International Aero Engines SERVICE BULLETIN

ENGINE FUEL AND CONTROL - DEDICATED ALTERNATOR
(STATOR) - INTRODUCTION OF REVISED RECEPTACLES

V2525-D5
V2528-D5

V2500-ENG-73-0096

General view
Fig 1

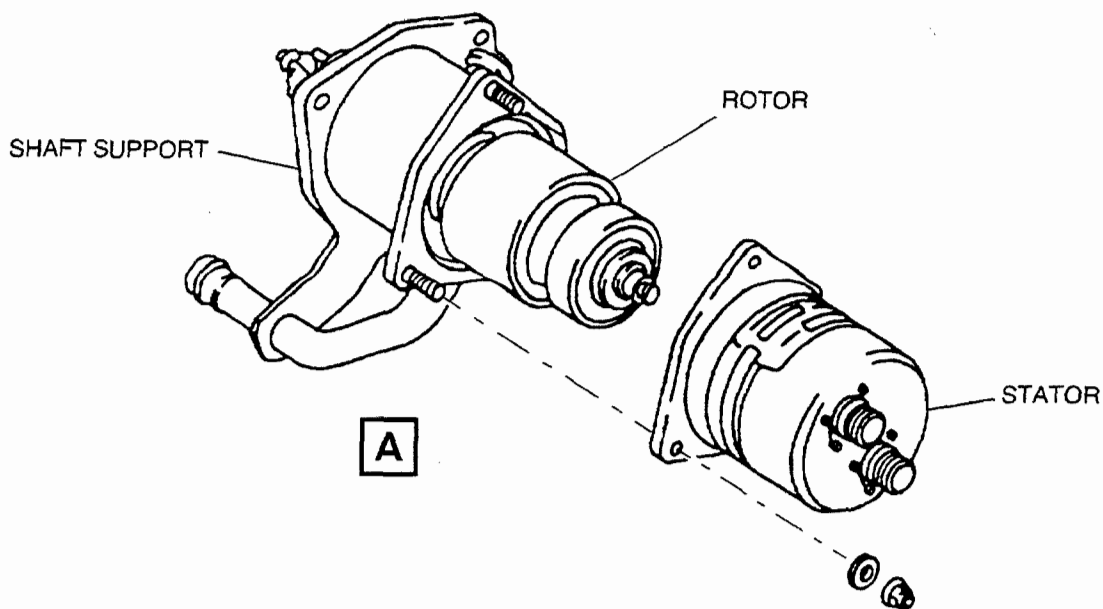
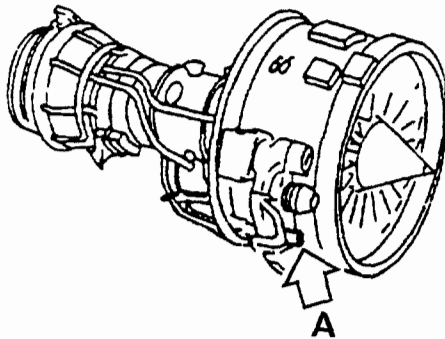
A revised Engine Dedicated Alternator (EDA) stator is introduced similar to the existing stator but with receptacles that feature improved locking features.

- (1) Install the revised Engine Dedicated Alternator using the approved procedures, Ref. Aircraft Maintenance Manual, Chapter/Section 73-22-38, Removal/Installation.
